V2 SUBMITTAL REVIEW _ Comments 07/03/2023

PSP 23-02 and CID 23-06

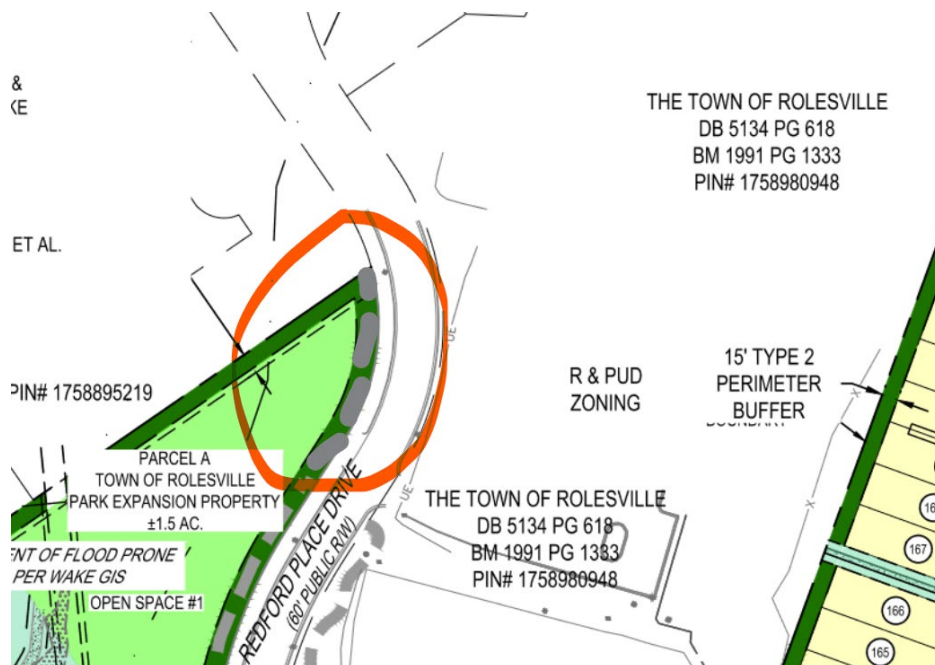
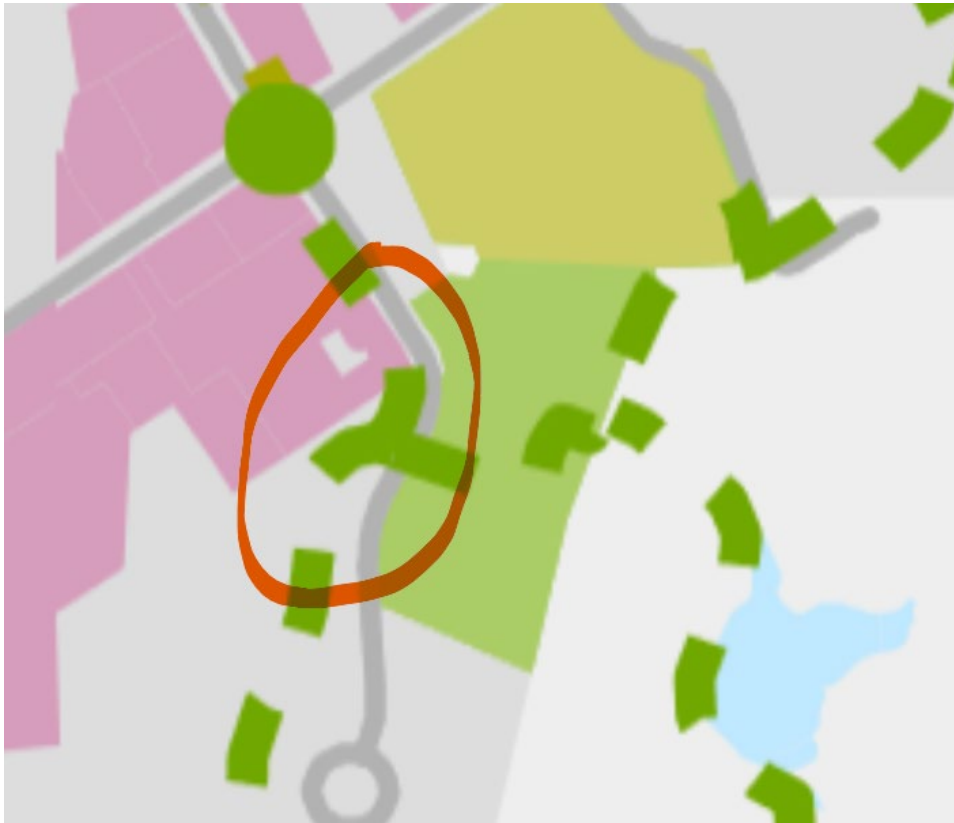
- 1.) The Town would prefer the Greenway to be as close to the sidepath on Street H as possible. As shown currently on the concept plan, greenway users will have to cross the street twice to get onto the sidepath and ideally there is only one road crossing. Please revise the greenway that runs along the north side of the pond towards Long Melford Drive to align with the sidepath on Street H. It does look like there is a structure there (see Green highlighter circle below), is there any way to route the Greenway around this?
